ALERT SERVICE BULLETIN
Bell Helicopter **TEXTRON**

NO. 407-07-75

SUBJECT: CARGO HOOK STRESS CORROSION CRACKS

Document No. 159-017-00 Rev 0

Figure 1. Crack location

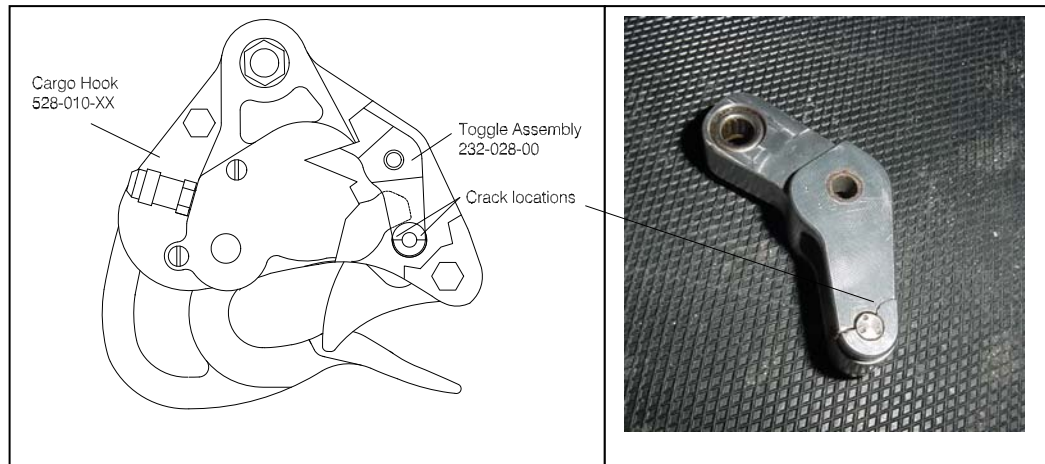
Description: Onboard Systems has had two reported instances of failure of the Toggle Assembly, 232-028-00. The Toggle is an internal component of Cargo Hook 528-010-XX and is a primary element of the Cargo Hook locking mechanism. Figure 1 shows the location of the failure.

Cause: Investigation of the failures has suggested that they were caused by Stress Corrosion Cracking (SCC). Specific mechanical, metallurgical, and corrosive conditions must be present in order for SCC to occur.

1. Residual stresses imposed by the press fit of the Load Beam Roller Pin
2. Corrosive salt water environment

Figure 2. Crack Locations in Toggle 232-028-00

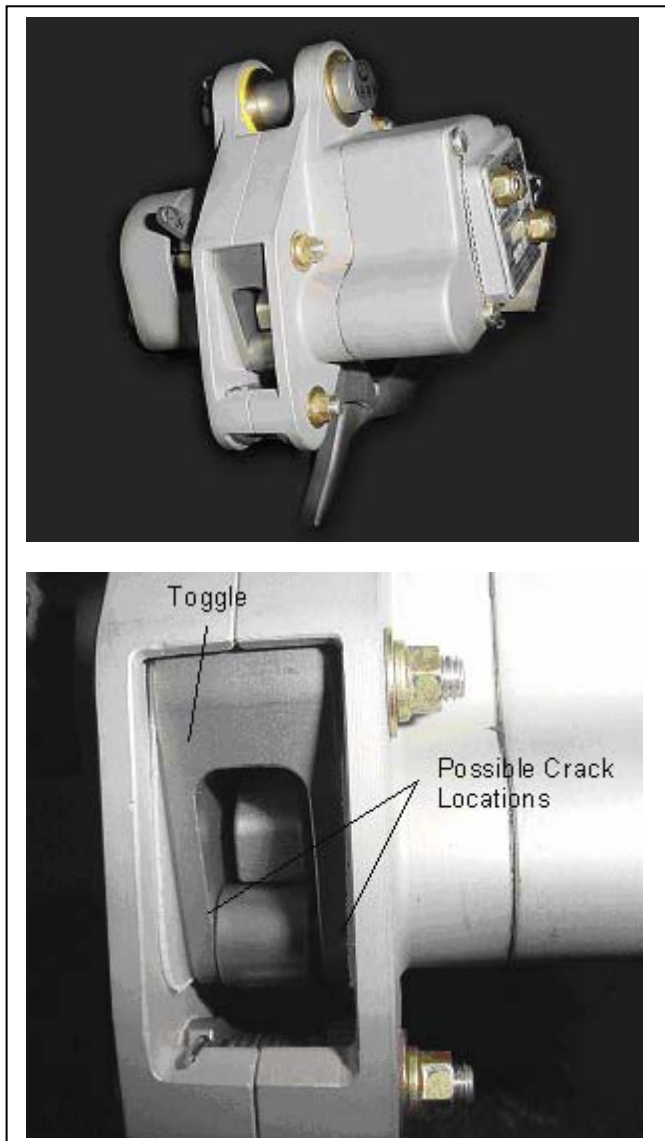
1. Visually check the Toggle for cracking or separation, as viewed in figure 2 in the assembled Cargo Hook.
2. Operate the Cargo Hook per the preflight instructions in the RFMS. If the Cargo Hook does not function properly, it must be removed from service and the part 2 instructions must be accomplished prior to use.

1. Remove Cargo Hook from aircraft. Refer to appropriate ICA or Owner's Manual instructions.
2. Disassemble Cargo Hook per Service Manual instructions. Remove Toggle 232-028-00 and replace with Toggle 232-028-01*.

**(The P/N 232-028-01 Toggle includes all the bearings and bushings installed and also a Load Beam Roller and Pin. The new Toggle can be distinguished from the old toggle by a 1 stamped on it. This will be visible after assembly.)*

Figure 4. Install New Thrust Plates.

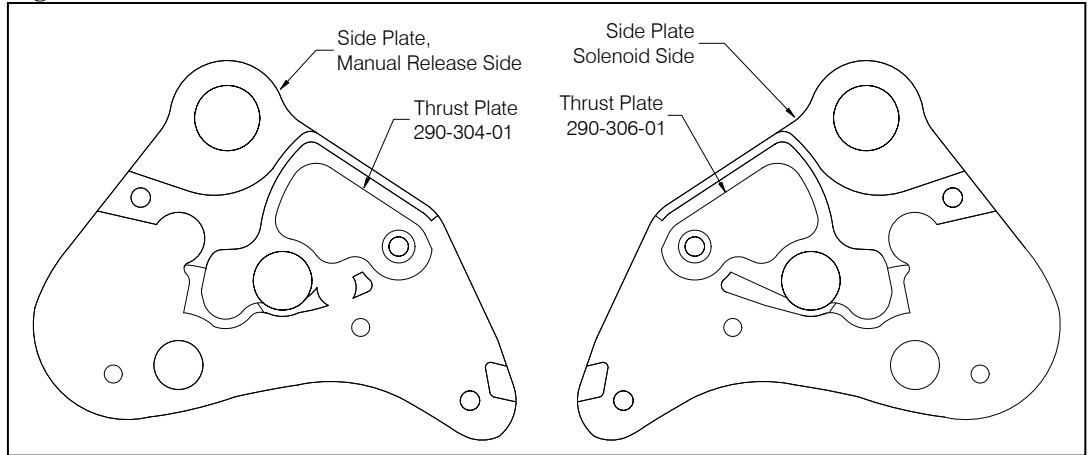
3. Remove Thrust Plates 290-306-00 from the inside of the cargo hook side plate on the solenoid side and 290-304-00 from the inside of the opposite side plate and replace with Thrust Plates 290-306-01 and 290-304-01 respectively as shown in Fig. 4**.

***The Thrust Plates must be replaced or the new Toggle will not function properly.*
